ADDENDUM NO. 1

| <i>DATE OF ISSUANCE</i> | April 23, 2012 |
| <i>PROJECT</i> | Louis E. Legg Middle School 175 Green Street Coldwater, Michigan 49036 |
| <i>ARCHITECT'S PROJECT NO.</i> | 11-165.30 |

A-1

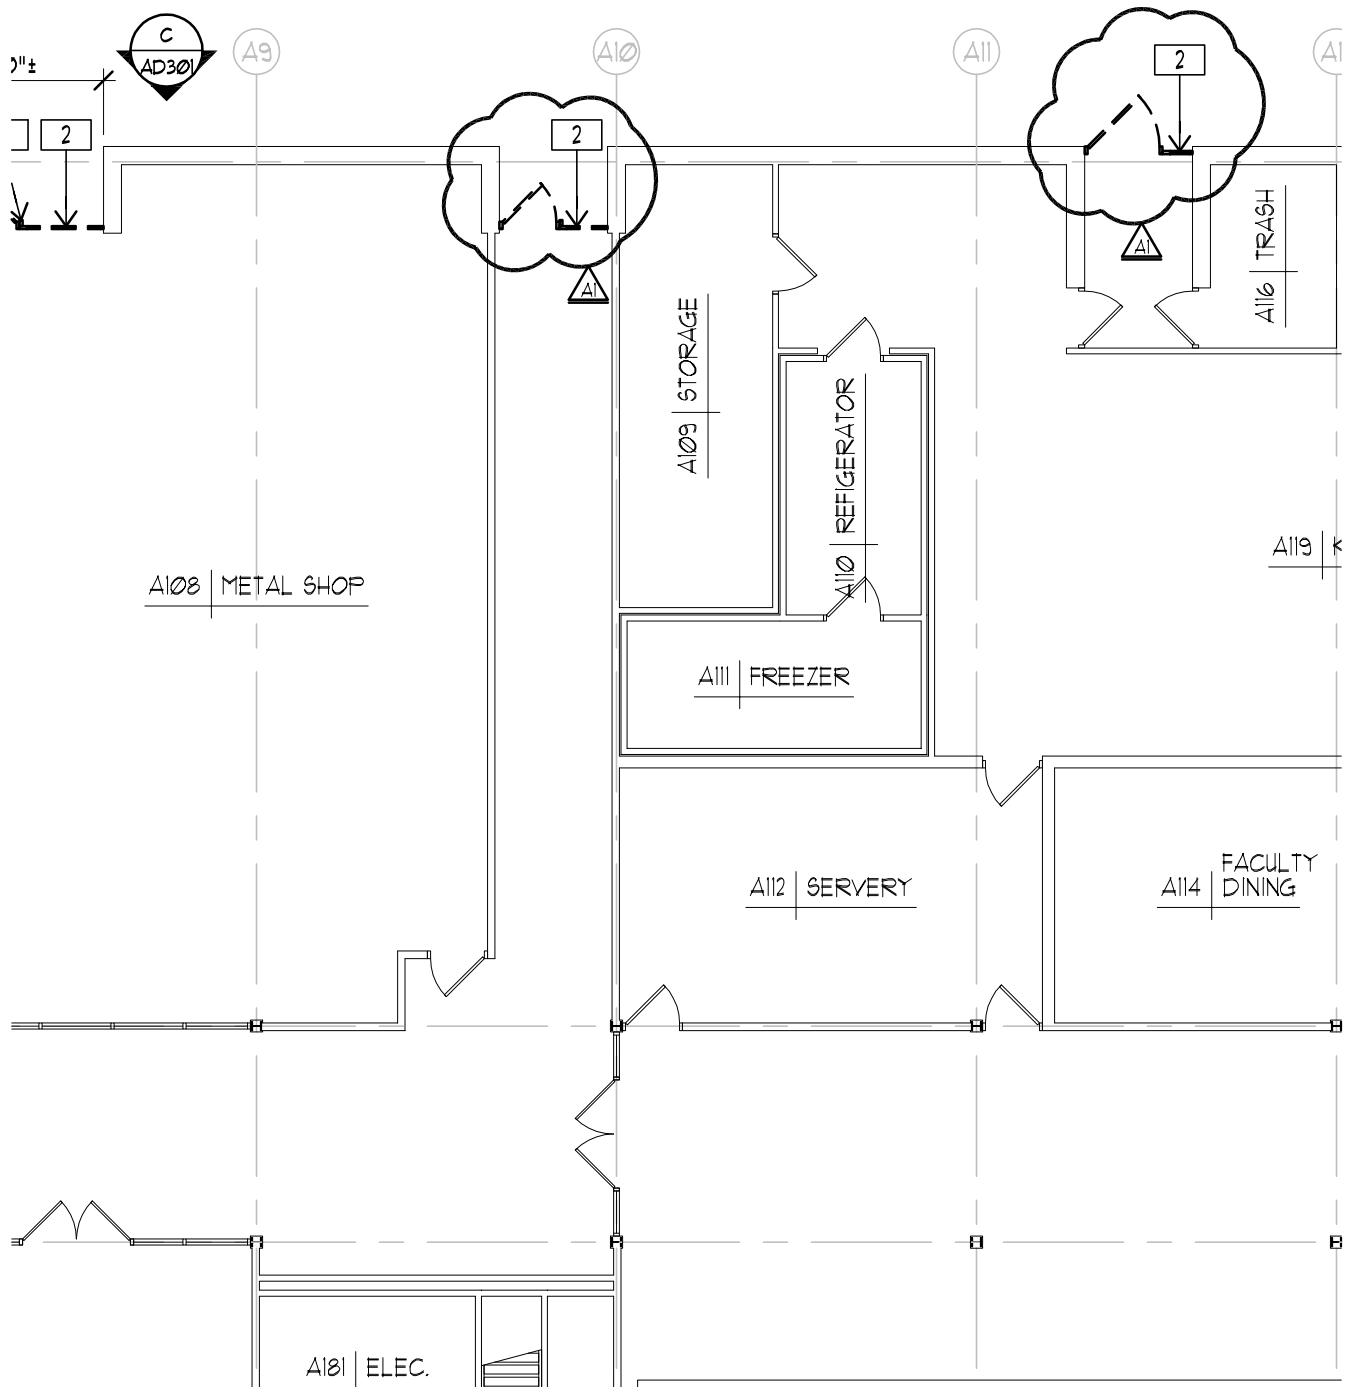
Refer to Drawing AD 101A (not reissued) and attached sketch A-1. Revised door near column line AF/A11 to match existing configuration and location. Added door near column line AF/A10.

A-2

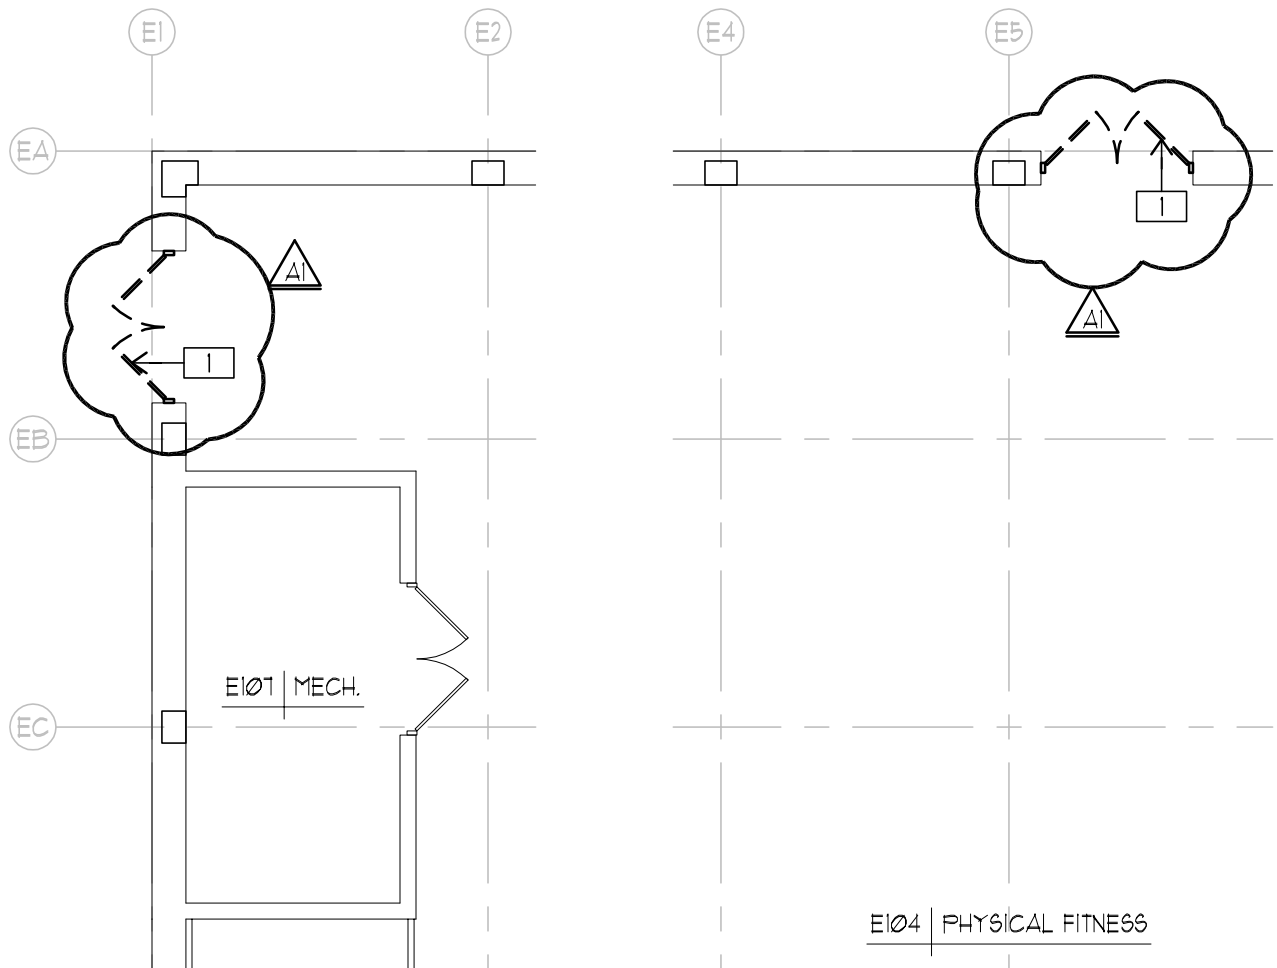
Refer to Drawing AD 101E (not reissued) and attached sketch A-2. Added doors at room E104 as indicated.

A-3

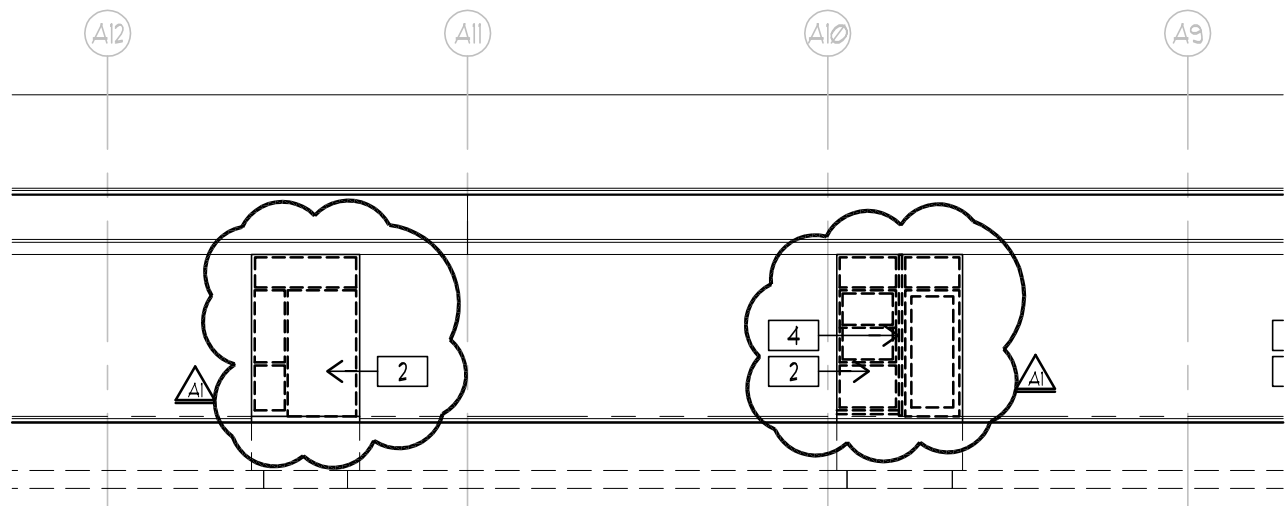
Refer to Drawing AD 301 (not reissued) and attached sketch A-3. Revised detail C/AD301 Unit A West Elevation as indicated.

A-4
APRIL 23, 2012
11-165.30

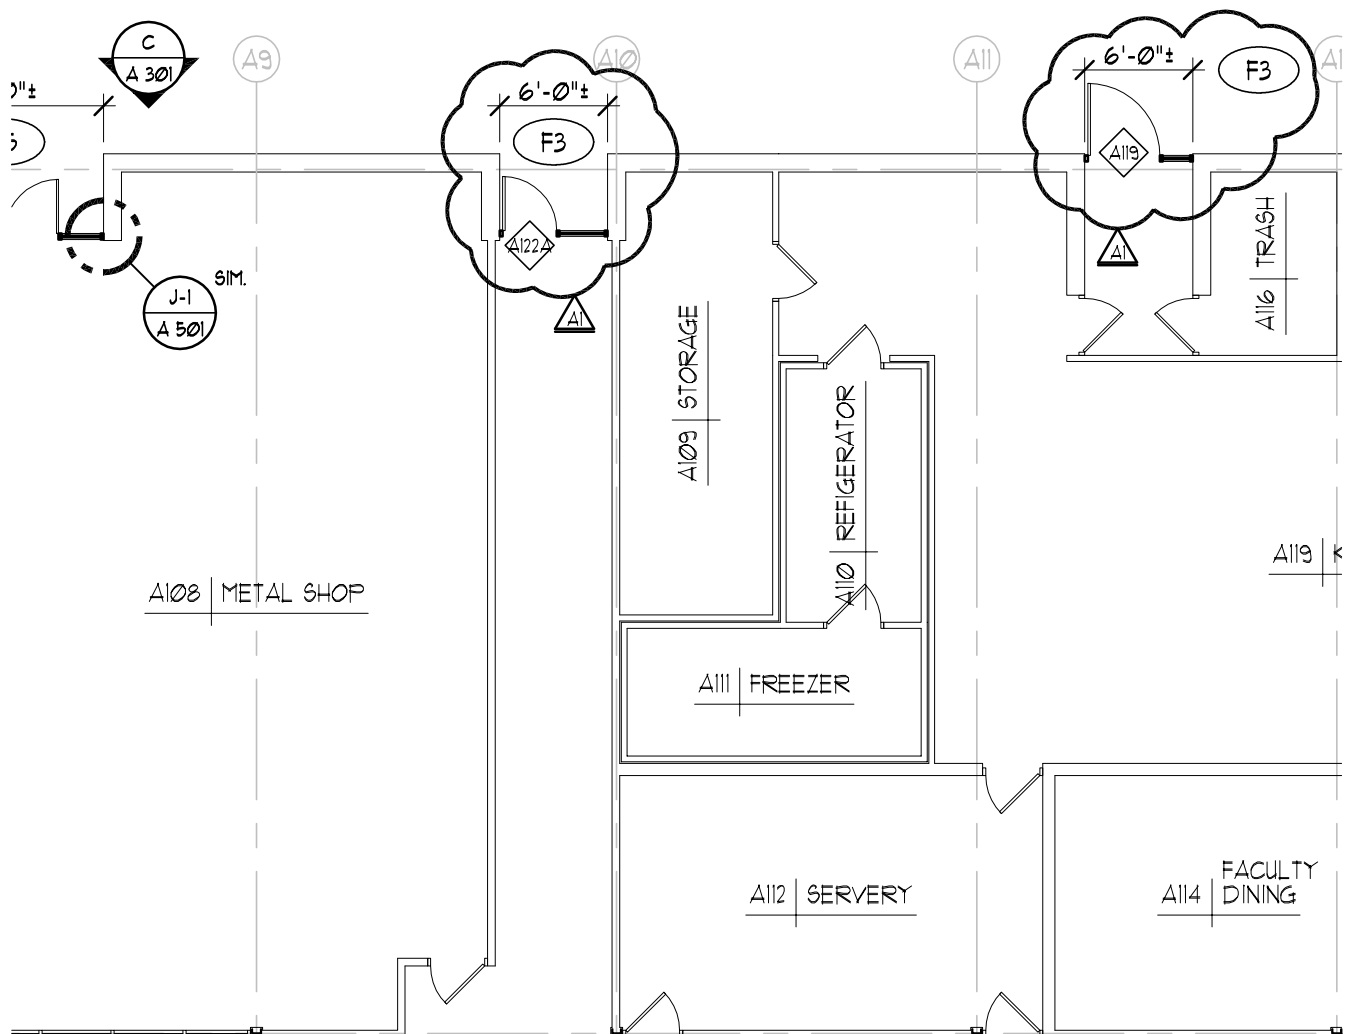
Refer to Drawing A 101A (not reissued) and attached sketch A-4. Revise door A119 as indicated. Add door A122A as indicated.

A-5
APRIL 23, 2012
11-165.30

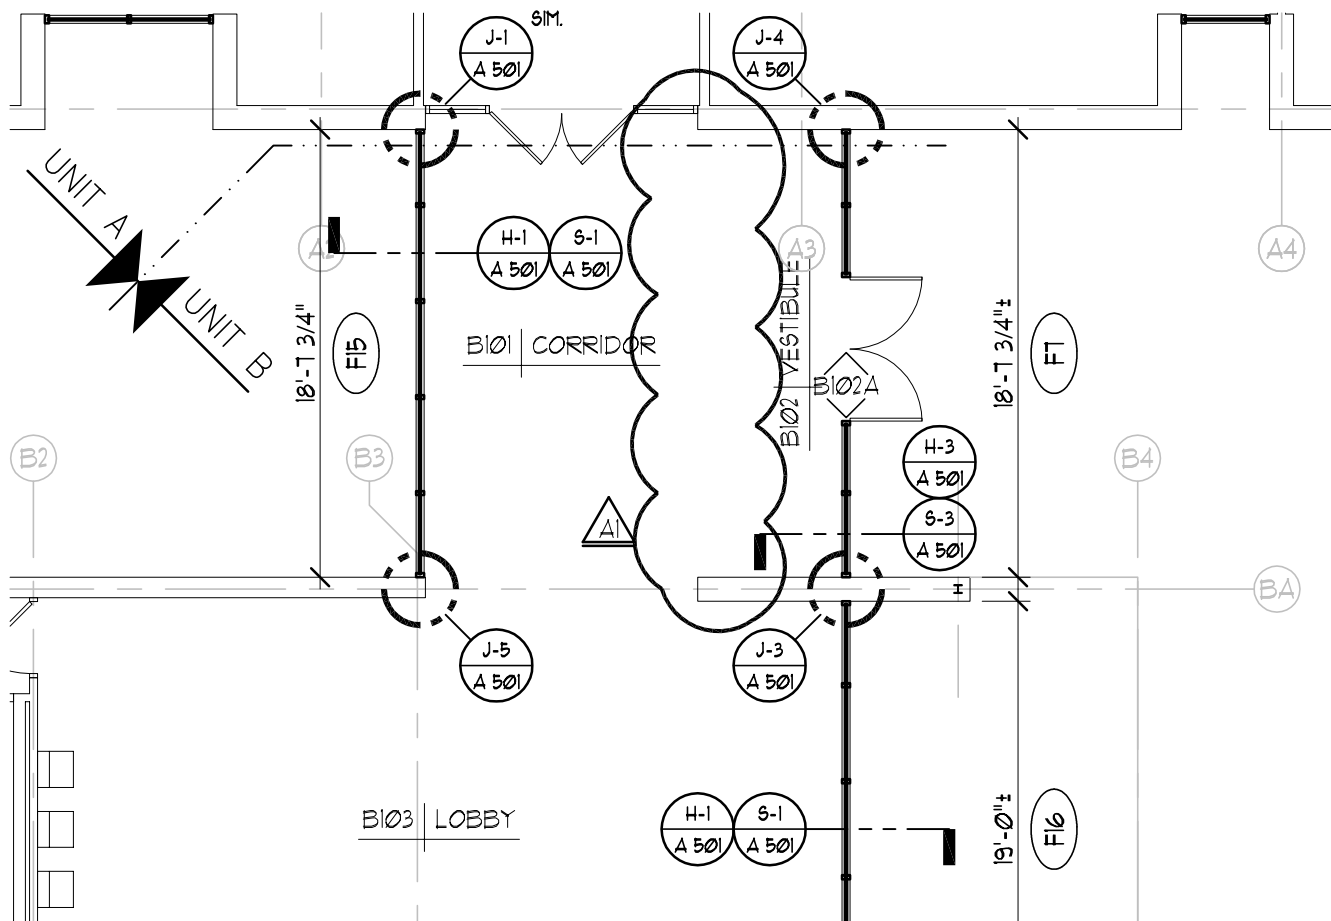
Refer to Drawing A 101B (not reissued) and attached sketches A-5, A-6, and A-7. Omit door and frames for door B102B, C102B, and D102B.

A-8
APRIL 23, 2012
11-165.30

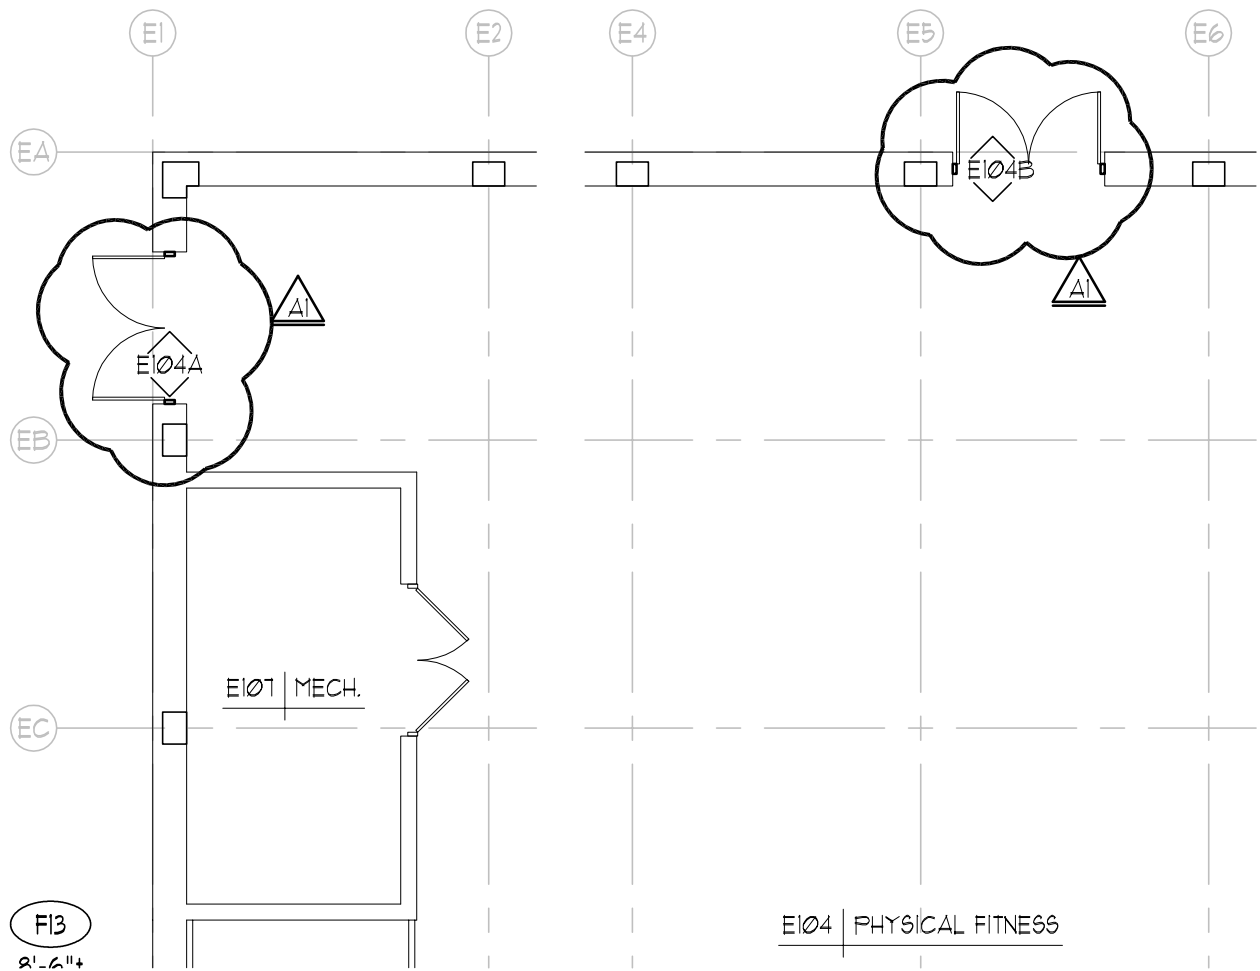
Refer to Drawing A 101E (not reissued) and attached sketch A-8. Add doors E104A and E104B.

A-9
APRIL 23, 2012
11-165.30

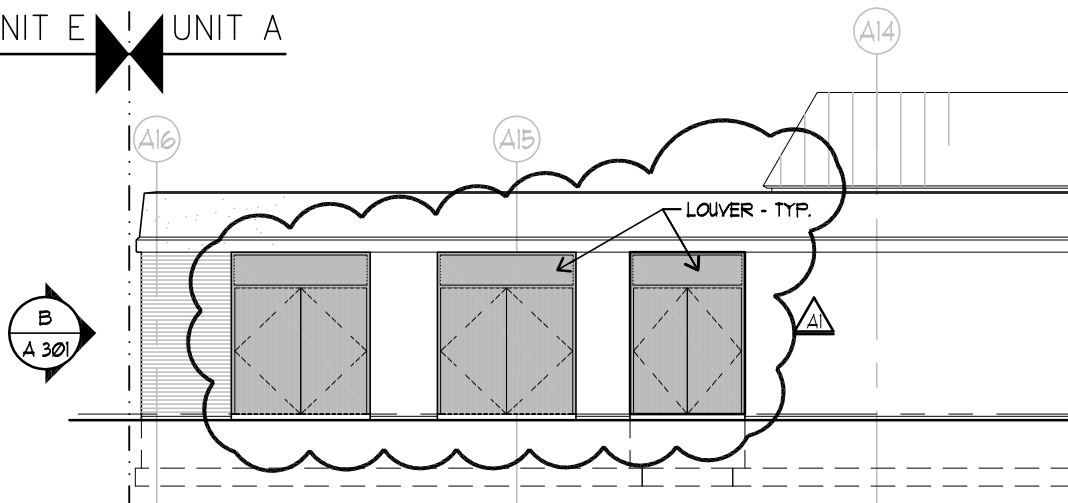
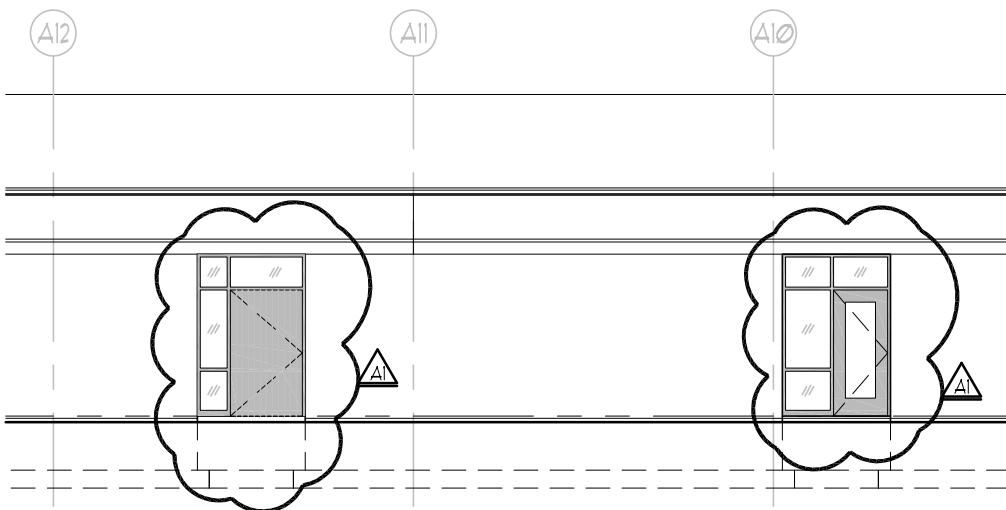
Refer to Drawing A 301 (not reissued) and attached sketch A-9. Revise detail C/A301 Unit A West Elevation as indicated.
